**RE: Mister Car Wash
2161 Gibson Blvd SE
Grading & Drainage Plan
Engineer's Stamp Date: 07/25/22
Hydrology File: M15D021B**

Based upon the information provided in your submittal received 07/26/2022, the Grading & Drainage Plan is **not** approved for Building Permit and Grading Permit. The following comments need to be addressed for approval of the above referenced project:

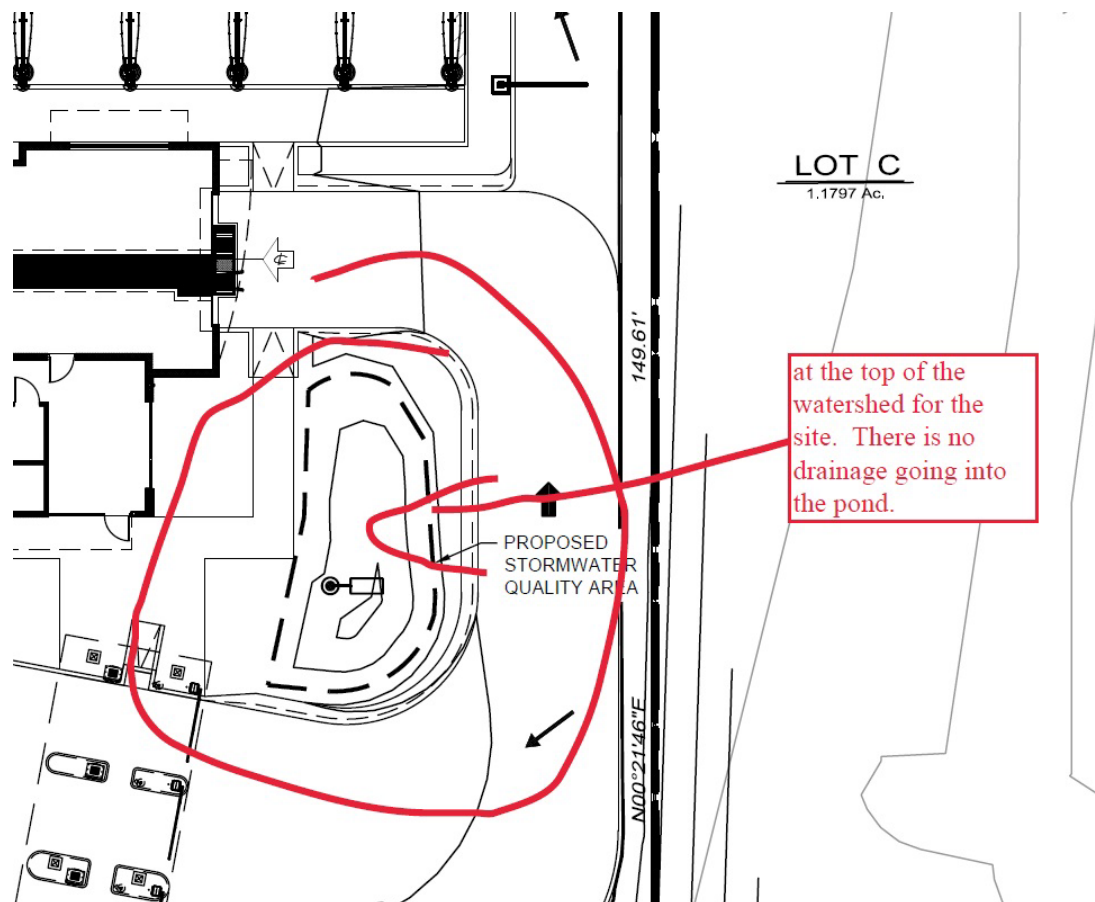
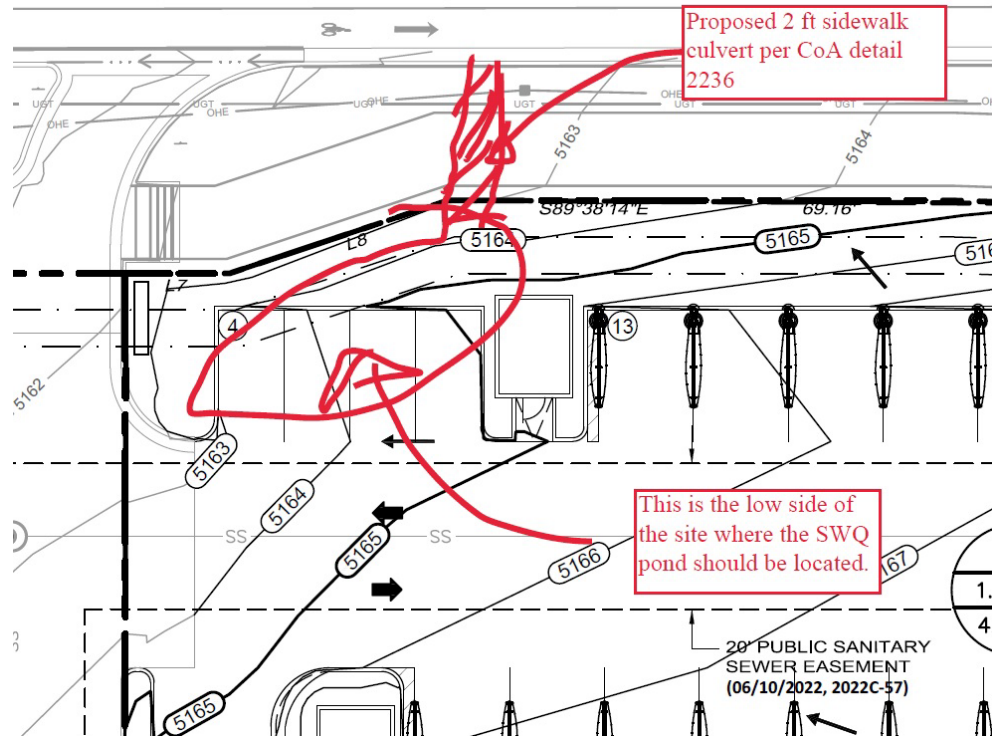
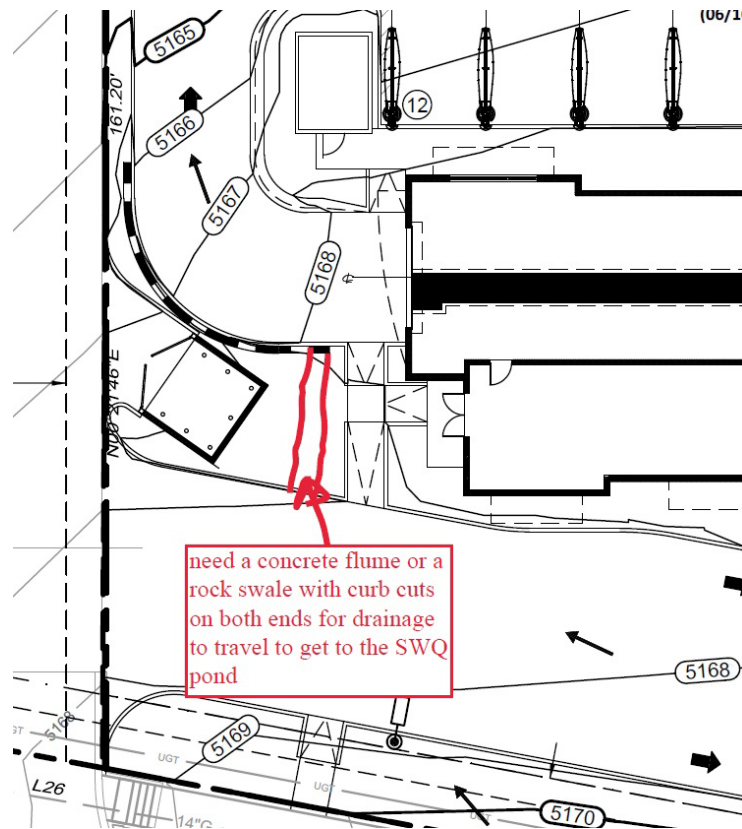
6. The onsite drainage should be directed to the stormwater quality (SWQ) pond prior to leaving the site. Currently you have the SWQ pond on the high side of the site with little drainage going into it. Also, please show the top and bottom of the pond along with the volume for the pond. The pond also needs a spillway in the form of a sidewalk culvert at the SWQ water surface elevation on the pond side and match the existing gutter elevation in Gibson.

7. Please reference City of Albuquerque standard detail No. 2236 – Sidewalk Culvert with Steel Plate Top at the sidewalk culvert.
8. Please add either a concrete flume (channel) or a rock swale with curb cuts on either end so that the drainage can travel to the SWQ pond.

SHEET NUMBER
C601

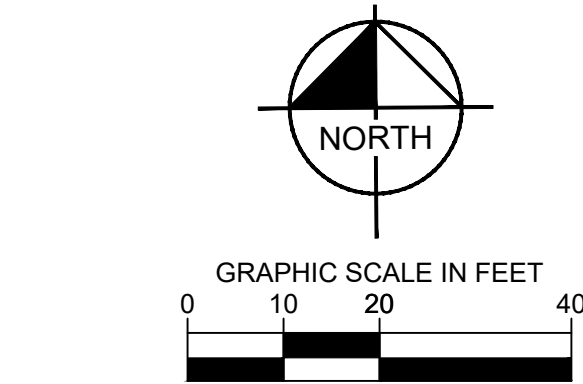
4. Please use the procedure for 40 acre and smaller basins as outlined in Development Process Manual (DPM) Article 6-2(a). Please provide both the existing conditions and proposed conditions for the 100 year-6 hour storm event.

5. Provide management onsite for the Stormwater Quality Volume (SWQV) in accordance with the Drainage Ordinance, § 14-5-2-6 (H) and the DPM Article 6-12 Stormwater Quality and Low-Impact Development for the sizing calculations. To calculate the required SWQV, multiply the impervious area draining to the SWQ pond by 0.42 inches for new development sites. Please show both the required and the provided volume.
